# LOWER MINNESOTA RIVER WATERSHED DISTRICT

#### Item 6. C– Merriam Junction Trail (LMRWD No. 2023-013)

# Technical Memorandum

**Re:** Merriam Junction Trail Project (LMRWD No. 2023-013)

Figure 3: Bridge R0910  
LMRWD No. 2023-013

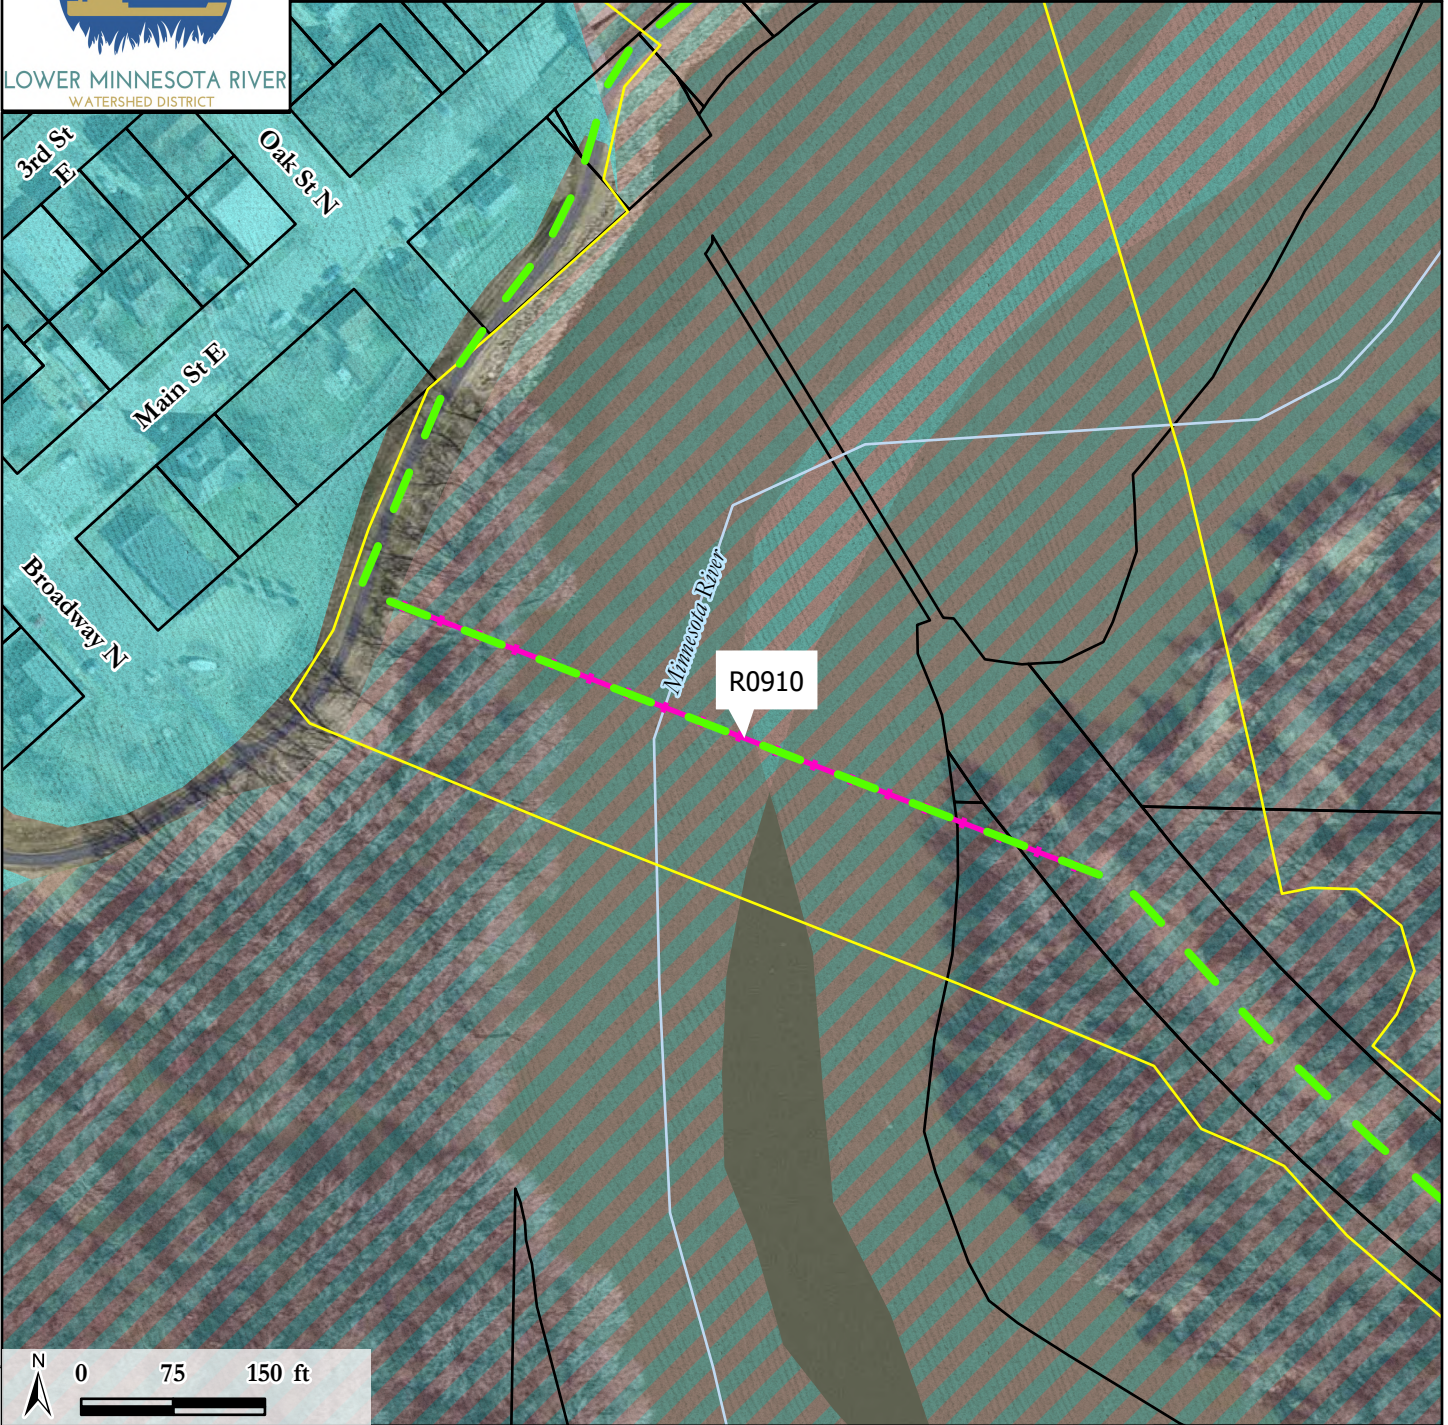
The project proposes 663 cubic yards of cut and 80,324 cubic yards of fill within the floodplain and no compensatory storage. The project requires excavation and filling to create safe elevation changes, clear trees, and stabilize the riverbanks. There are two bridges proposed within the LMRWD (Figure 3 and Figure 4). Bridge R0910 is a continuous steel girder bridge crossing the Minnesota River. There is an additional floodplain relief bridge within the LMRWD (Bridge R0909) that will consist of prestressed concrete beam crossings. The proposed conditions are modeled showing the excavation and fill required for the trail construction. SRF Consulting has provided cut and fill maps, construction plans, and bridge plans to accompany the HEC-RAS model. The proposed model shows no change in the 100-year water surface elevation, meeting the minimum requirements of Rule C.
